Technical BULLETIN

CERTAIN 2020 YZ250FX MODELS

Rich Running Condition - ECU Reprogramming

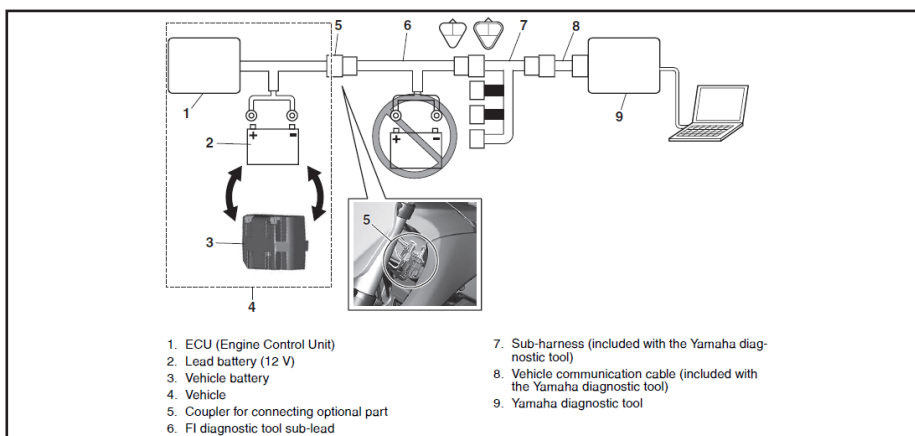
Problem: Some units may experience a condition where the engine is hard to start due to a fouled spark plug.

Cause: The 2020 YZ250FX's ignition timing and air / fuel ratio were set to meet this model's target of good low speed torque for off-road closed-course competition. When riding in certain conditions, the slightly retarded ignition timing and richer air / fuel mixture may lead to the spark plug fouling, causing a hard-starting condition.

Original ECU Programming

Revised ECU Programming

Remedy: To remedy this condition, Yamaha has revised the ECU programming to address the rich running condition.

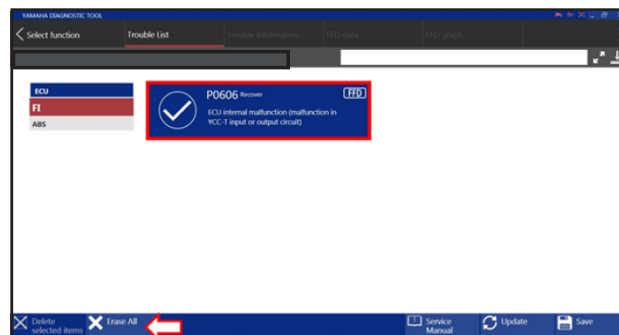
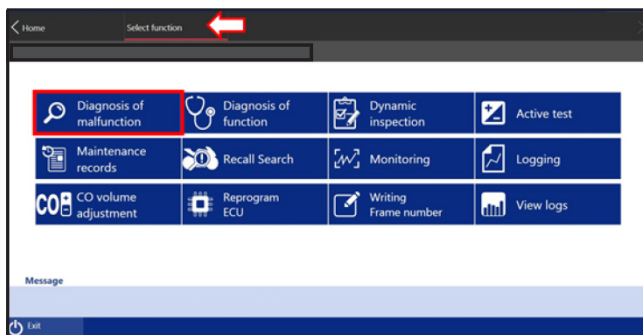
- Once the “reprogramming completed” message displays, confirm the Reprogram date change from “00...” to the actual date (formatted YYYYMMDD) on the before/after reprogramming chart as shown below.
